THE ENSTROM HELICOPTER CORPORATION

SERVICE DIRECTIVE BULLETIN NO. 0065

REVISION B

SUBJECT: Tail Rotor Driveshaft Spline Couplings, PN 28-13609

Figure 1. Checking inner spline wear on coupling.

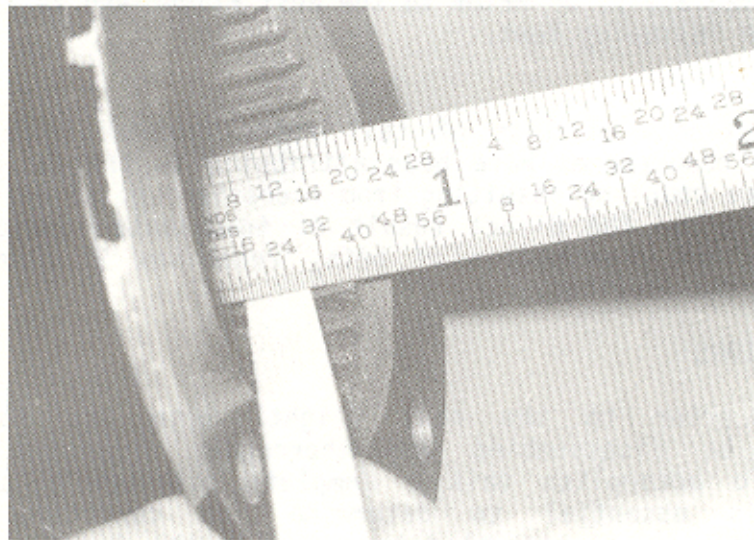
- A. The crown of the female coupling spline is approximately .040 inch in width. If the wear pattern is in excess of .010 inch, it is unairworthy and must be replaced by a serviceable component. The procedure to measure the wear on the female section splines is illustrated in Figure 1.

NOTE: Tooth wear is measured by placing a 6 inch steel rule parallel to the crown at the top edge of the driven side. A piece of .125 x .010 inch shim stock is then placed between the tooth and the rule, and pressing the rule against the tooth, check if the shim can be removed. If the shim slips out, the coupling is to be rejected and replaced with an air-worthy component.

Figure 2. Checking outer spline wear on male coupling.

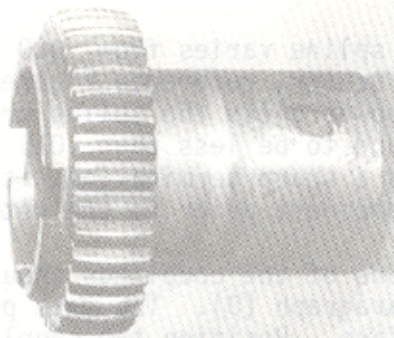
- B. The crown of the male coupling spline varies from .030 inch at the ends to approximately .020 inch at the center, reference Figure 2. By using a steel 1/100ths scale and a 10 power glass the spline crown should be measured at the center. If found to be less than .015 inch, and has rolled burrs on its edge or has a sharp termination, it must be rejected and replaced by an airworthy component prior to the return to service.

Figure 3.
 Checking hardness on male
 portion of coupling.

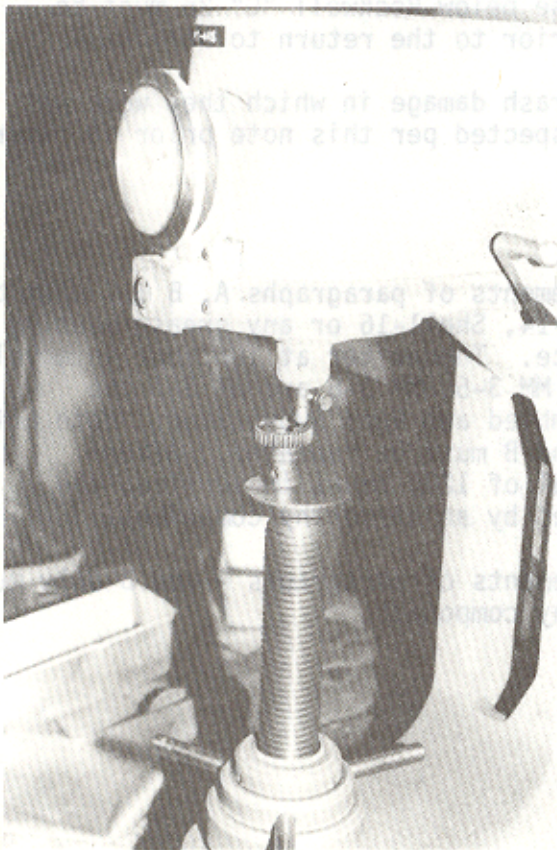
- C. Both the male and female portions of the couplings should be checked for material hardness, reference paragraph (D). The male portion should be checked on the inner circular face. Position the coupling half with the splined end and inner face looking up on the Rockwell machine support mandrel, making the inner face accessible, reference Figure 3. The female portion should be placed with its inner diameter over the mandrel and the attaching stub facing up. The end of the stub should be checked, reference Figure 4. Care should be taken when checking the hardness to properly support the components, and the surfaces to be checked should be clean and smooth. Three readings should be made on each half to obtain a good average on the Rockwell "C" scale. Components that average Rockwell "C" 25 or higher are acceptable; those below Rockwell "C" 25 must be replaced by an airworthy component prior to the return to service.
